Re: Call Sign E080100: Applications of Row 44, Inc. for
Authority to Operate up to 1,000 Technically-Identical Aeronautical-Mobile
Satellite Service Transmit/Receive Earth Stations Aboard Commercial and Private
Aircraft, FCC File Nos. SES-LIC-20080508-00570; SES-AMD-20080619-00826;
SES-AMD-20080819-01074; SES-AMD-20080829-01117; and
Special Temporary Authority, FCC File No. SES-STA-20080711-00928.
Notice of Ex Parte Presentation

Row 44 Continuing Issues

FIGURE 4.1.2-4 Antenna Gain in dBi for 14.05 GHz (Horizontal Polarization)
(25.209 Expanded Azimuth)

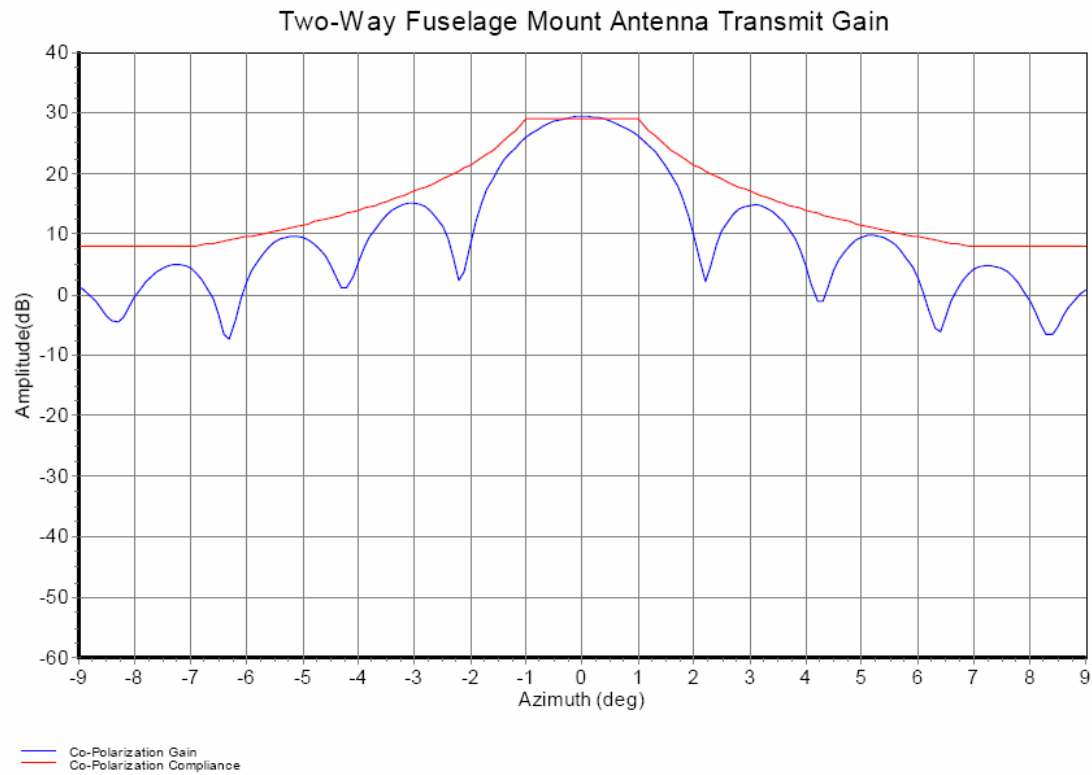
Row 44 Azimuth Antenna Pattern

0 deg Skew Off-Axis EIRP Density vs Theta and Mispointing

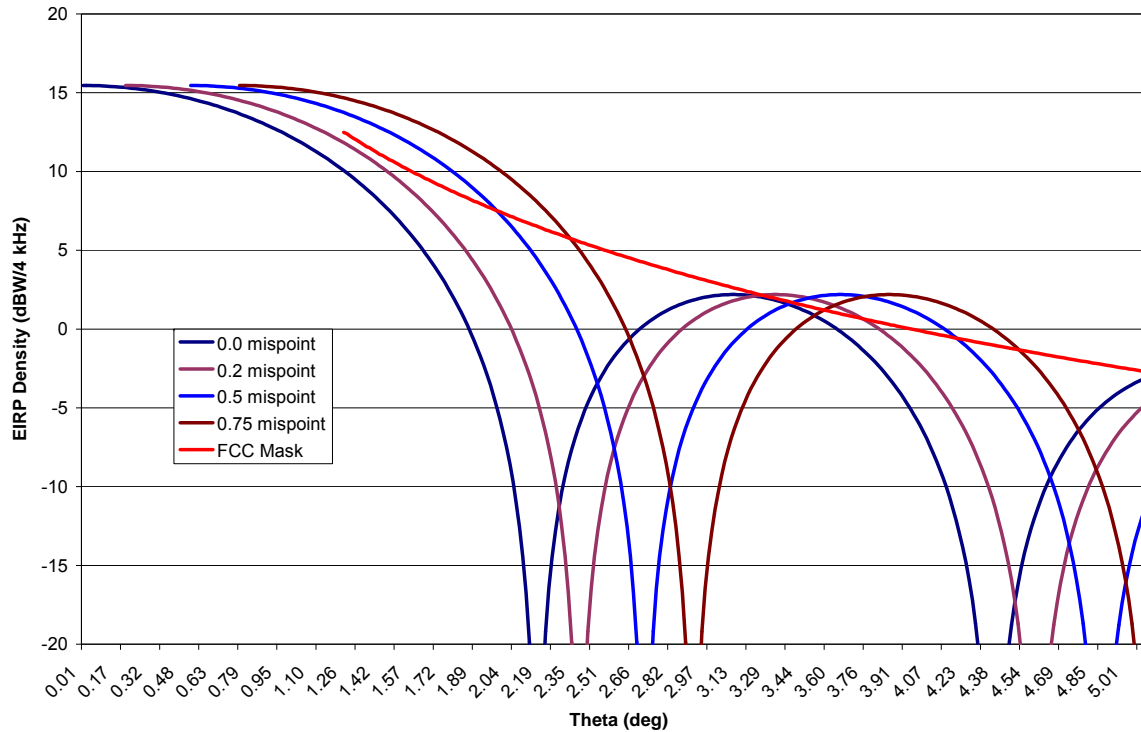
- Pointing error is greater than Row 44's claimed 0.2° peak value
- Return Link Budget issues
 - **Several changes were made to link parameters such as spreading, modulated bandwidth, and power reduction, but no new link budgets have been supplied for 512 kbit/s**
 - **Use of 2.1 dB Eb/No value is unrealistic. 3.3 dB Eb/No value more realistic but requires Row 44 to transmit additional EIRP**
- Careful control of EIRP needed because off-axis EIRP density exceeds FCC mask if pointing accuracy falls below 0.2° or skew reaches 25°

Return Link Budgets

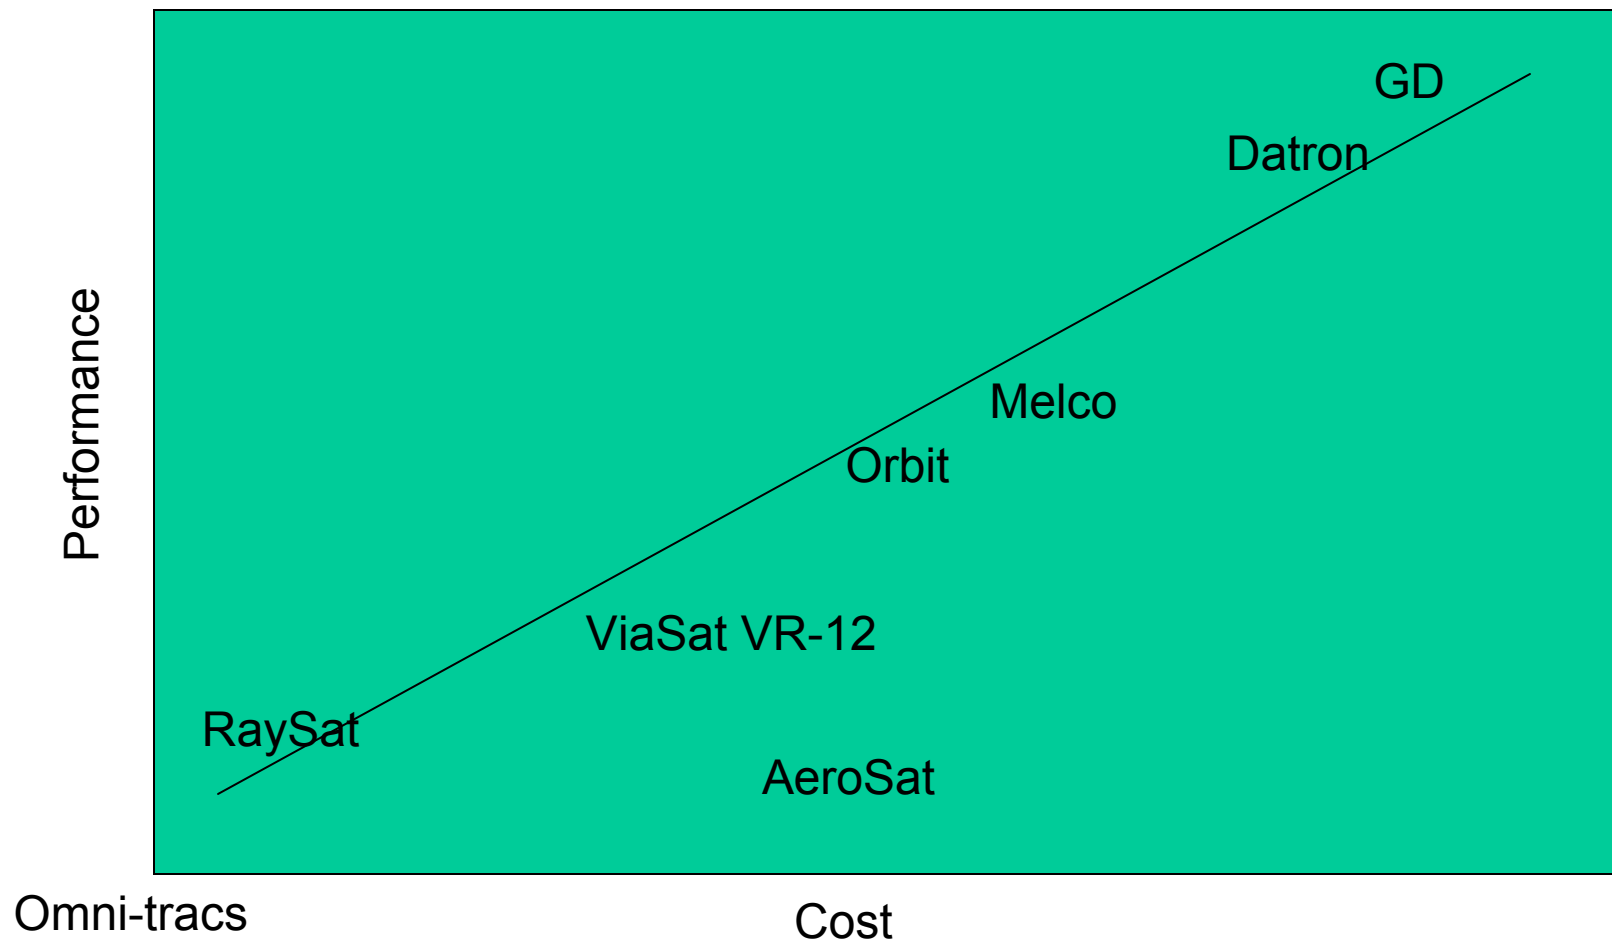
- **Carrier noise bandwidth calculation still not correct**
 - Uses 1.6 MHz as the necessary bandwidth in their antenna input power density calculation versus 1.024 MHz – the bandwidth shown in their modulation plot
- **2.1 dB Eb/No value not realistic – more likely in the 3.3 dB range**
 - Requires Row 44 to transmit higher than claimed EIRP
- **No 512 kbit/s link budgets**
- **No satellite G/T footprint contours**
